Lower Thames Crossing

9.53 Comments on WRs Appendix E – Ports

DATE: August 2023
DEADLINE: 2

Planning Inspectorate Scheme Ref: TR010032
Examination Document Ref: TR010032/EXAM/9.53

Plate A.1 Location of points used in Tables 6 and 7

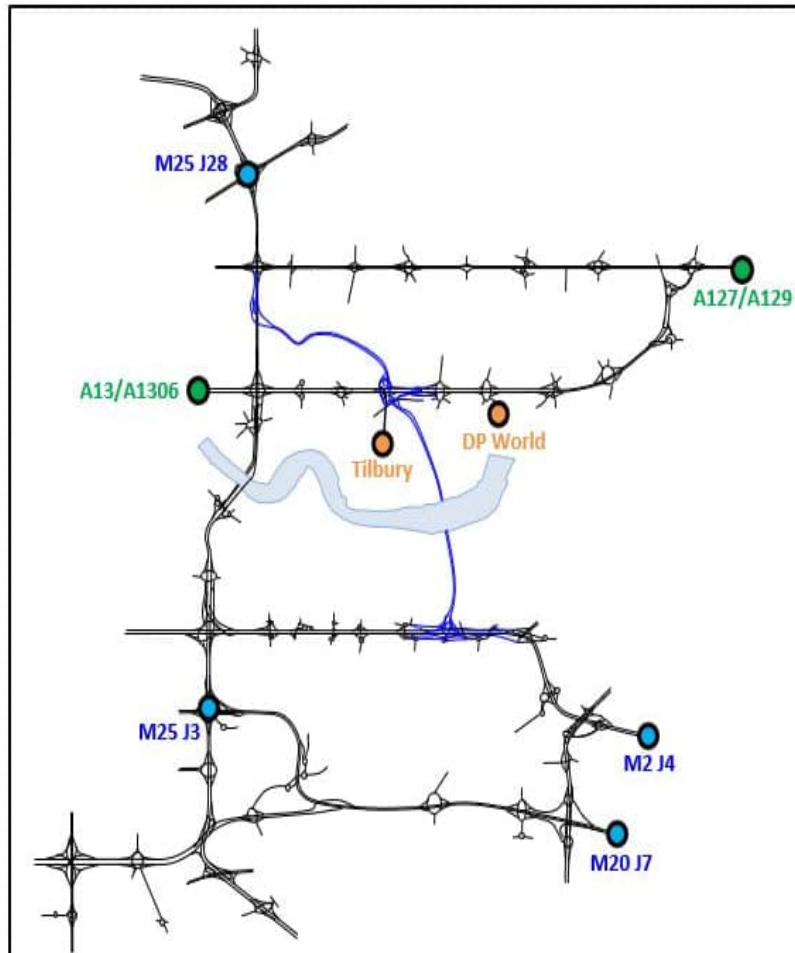
- A.1.4 DPWLG have expressed concerns over the change in forecast traffic flows once the Project opens. They are concerned about traffic conditions at the A13 Orsett Cock junction and that would lead to a high number of vehicles U-turning at the Manorway junction, adding to the traffic on the circulatory at Manorway and blocking access to the A1014.

A.2.2 Table 7 shows the change in travel time from the London Gateway Port in each direction. The locations used are shown in Plate 1. In each table the time for the quickest route once the Project opens is shown. For some trips this is the existing route, but with the journey times enhanced, and for some trips the preferred route is changed and would use the Project because of the time savings and the shorter route it provides. Time changes for other destinations south of the River Thames for each of the LTAM forecast years are provided in Tables 8.17 to 8.22, 8.38 to 8.43, 8.59 to 8.64 and 8.80 to 8.85 of Combined Modelling and Appraisal Report Appendix C: Transport Forecasting Package [[APP-522](#)].

- A.2.3 The comparison of travel times in Tables 6 and 7 show that journeys to London Gateway Port passing through M20 junction 7 and M2 junction 4 would have substantial time savings as a result of switching route to use the Project. In the 2030 AM peak hour HGVs would have a change in their travel time from M20 junction 7 to London Gateway Port from 61 minutes to 42 minutes, a saving of 19 minutes. From M25 junction 28 HGVs would have a change in journey time in 2030 AM peak hour, from 21 minutes 42 seconds to 18 minutes 13 seconds. For many journeys that remain on the same routes there would also be a reduction in travel times, for example for trips passing M25 junction 3.
